**CITY OF CHARLOTTESVILLE  
BOARD OF ARCHITECTURAL REVIEW  
STAFF REPORT  
August 18, 2015**

BAR 15-08-06

102 1<sup>st</sup> Street North

Installation of low clearance structure at 1<sup>st</sup> St NE Entrance of First and Market Parking Lot

**PARKING LOT PLAN**

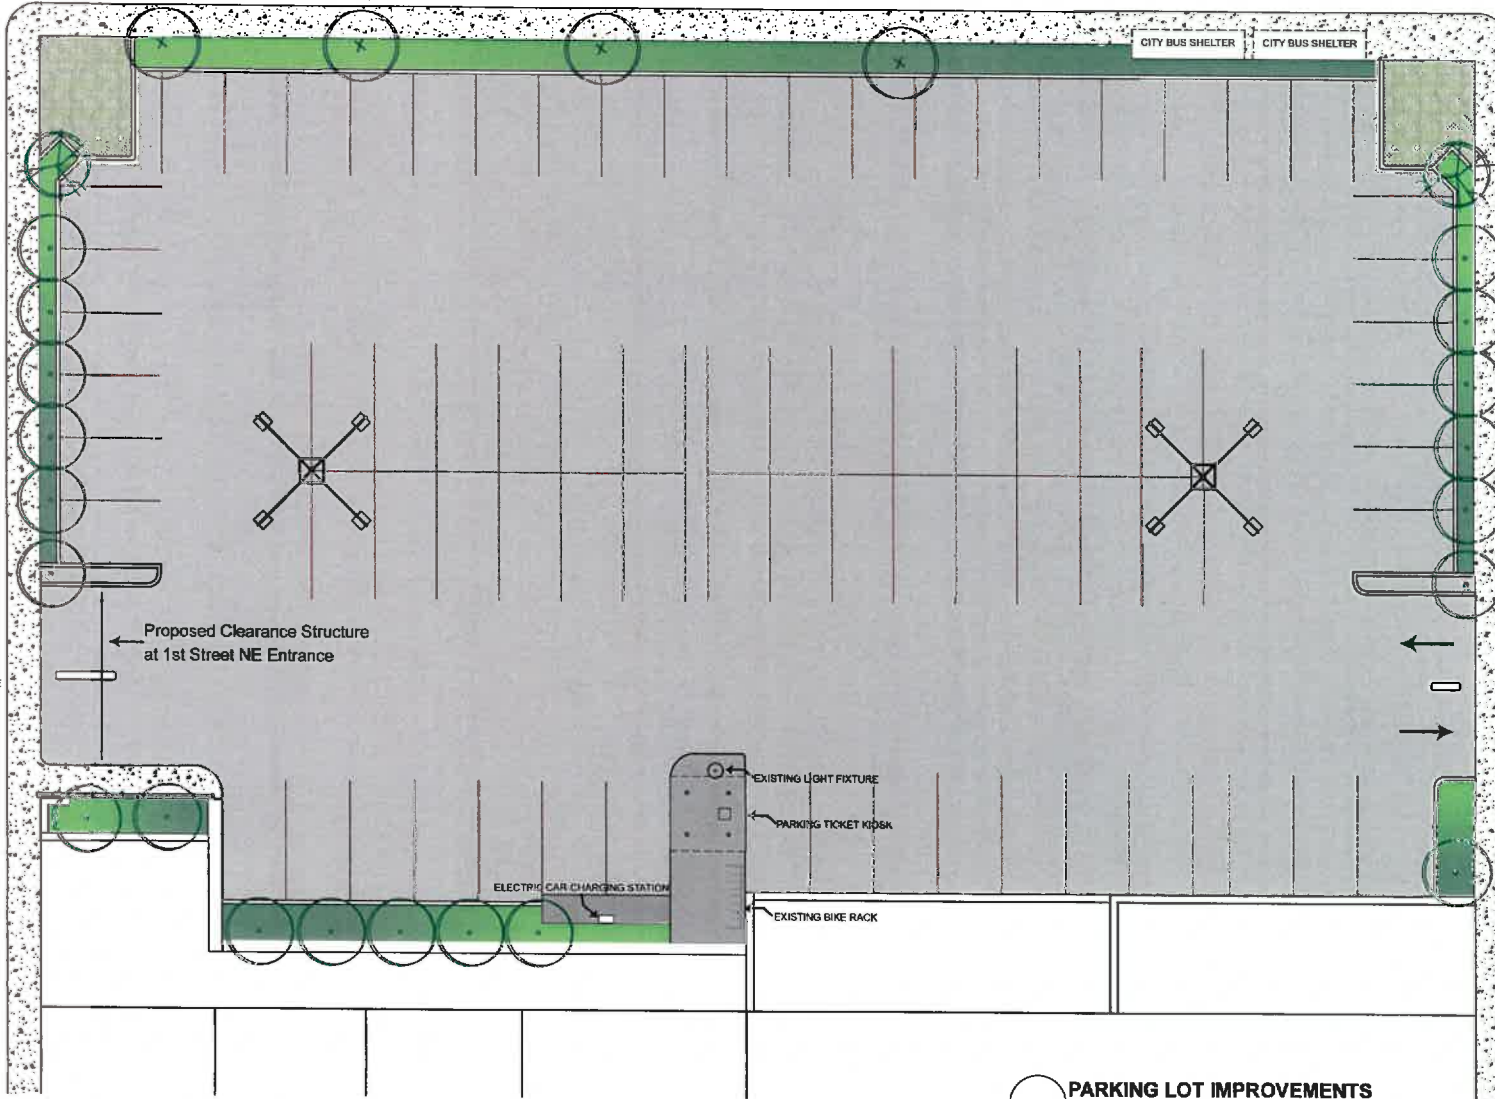
I know the question about the absent trees will come up at the BAR meeting when they see your plan for the low clearance bar.

The previous approval said the planting plan was supposed to be approved administratively. What is your current plan regarding planting those trees?

While the trees in the middle of the parking lot seemed like a good idea, in reality it seems unlikely that they would do well there. Instead we are proposing to add substantial planting along the perimeter of the parking lot except where there are existing trees along Market Street. We are suggesting that Crepe Myrtles would be a good choice, however we are open to other suggestions. Crys will be sending a drawing that reflects this plan.
